**Project Title: Land South of Tollgate Road Colney Heath**

**Report Reference: JNY11289-06**

### HERTFORDSHIRE COUNTY COUNCIL – HIGHWAY RESPONSE II

## Appendix 1 – Revised Access Plan

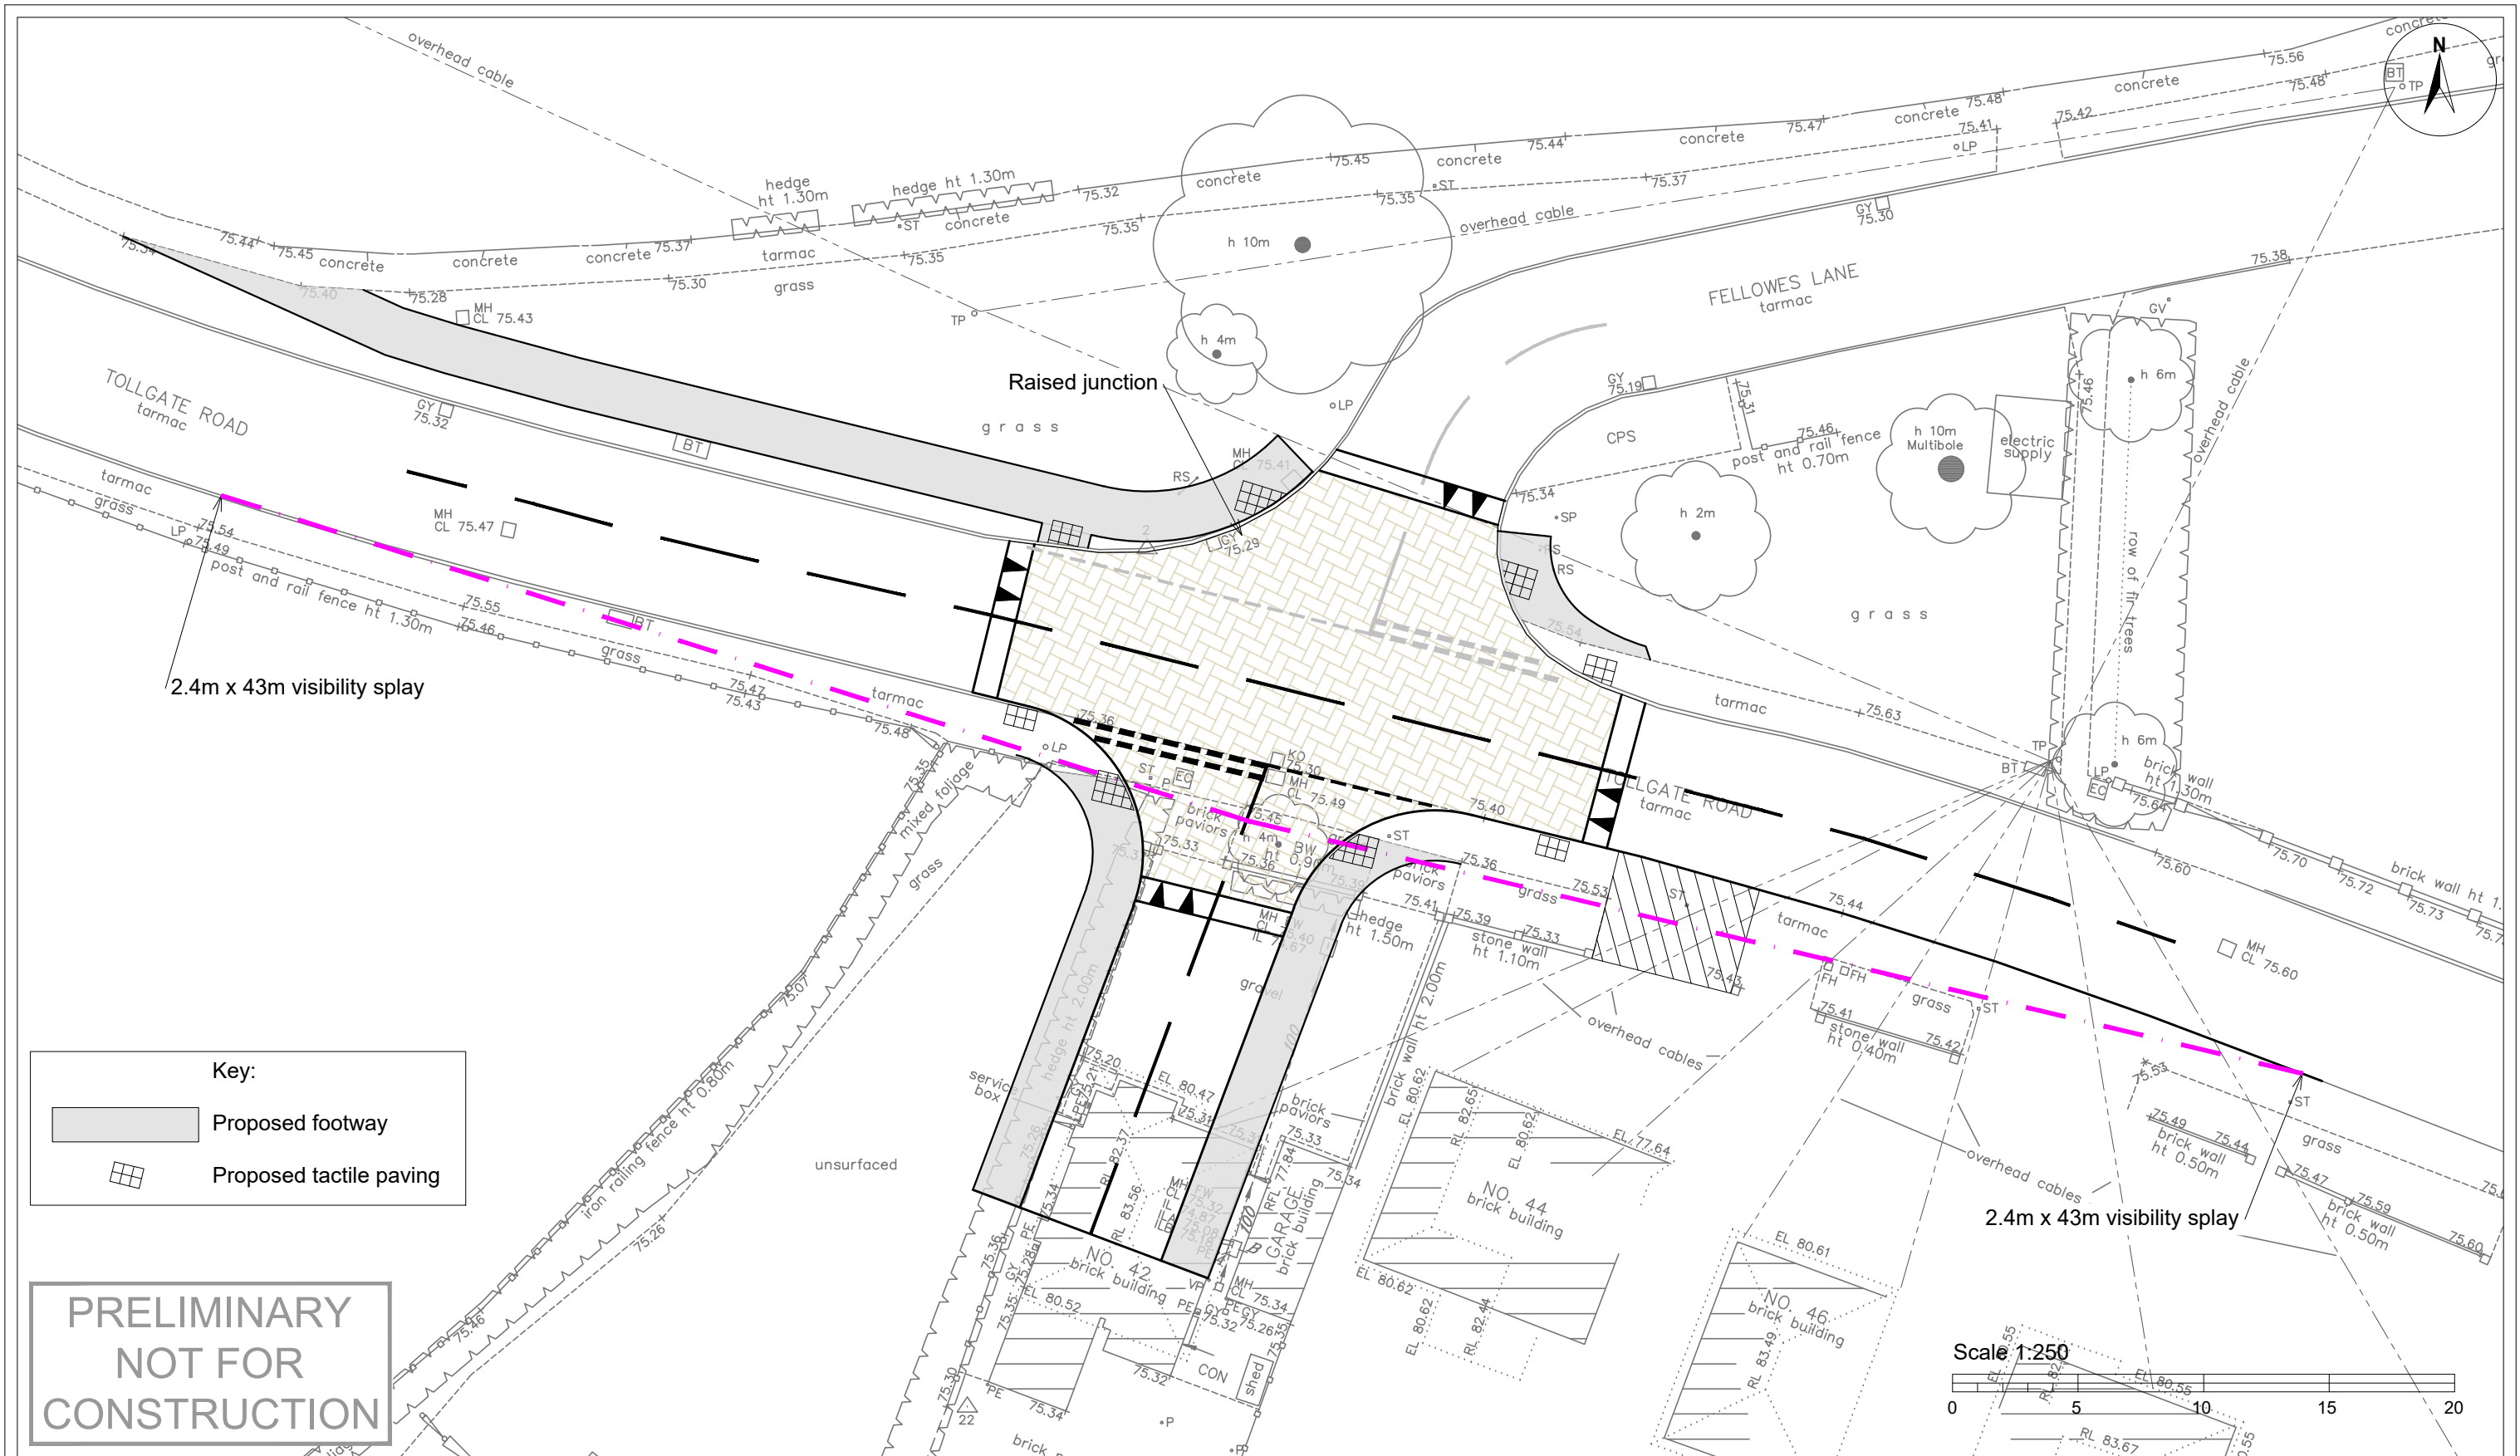
**1. Request for ‘An updated site access plan showing pedestrian crossing facilities at the site access’**

The Audit Team can confirm that after reviewing the proposed changes, which include the addition of tactile paving, that no new Problems would be raised as a result.

We are satisfied that this design change would address Problem 1 but the two General Problems and Problem 2 and 3 would remain as raised in the original Stage 1 RSA report.

You prepared the attached RSA1 for us May last year. In response to our planning application the Highway Authority have asked us to provide a new RSA1 on the updated layout that includes pedestrian crossing tactile paving details, which was one of your recommendations. No other changes to the layout have been made.

Please can you confirm whether the addition of the tactile paving to the plan has any material change to your recommendations, other than addressing 3.4.1?

- 1.2 The access plan has been updated to show pedestrian crossing facilities with tactile paving. The revised access plan is provided at Appendix 1.

B	Pedestrian crossings added	AJ	ID	31.01.23
A	Updated Highway Boundary	GM	MSB	27.06.22
Rev	Description	By	CB	Date

Title: Offsite Mitigation Measures

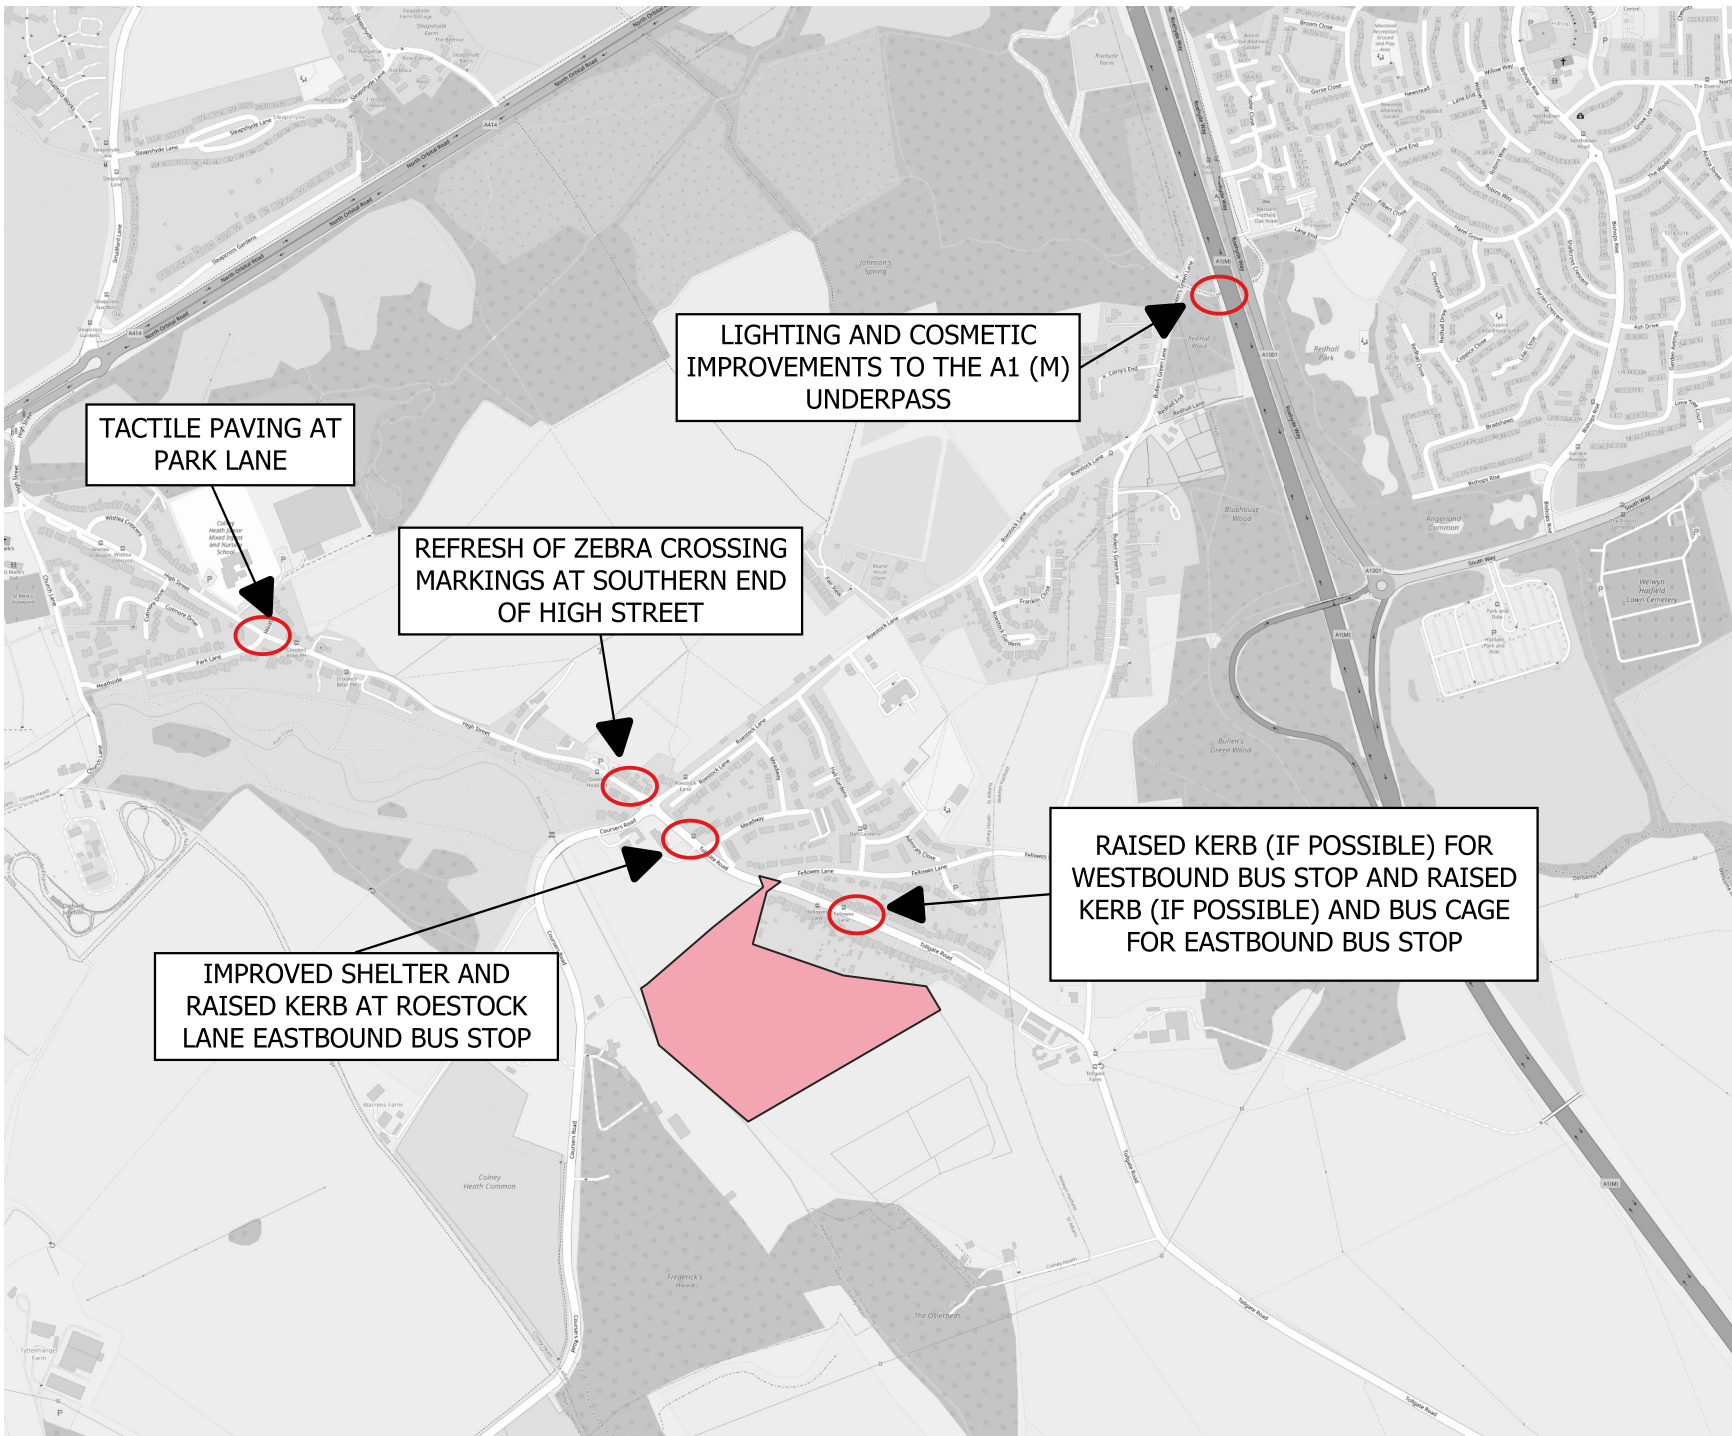
**2. Request for ‘A plan showing the location of proposed mitigation measures’.**

- 1.3 A plan has been provided showing the locations of the proposed mitigation measures highlighted by the walking and cycling audit. The plan is provided at Appendix 2.
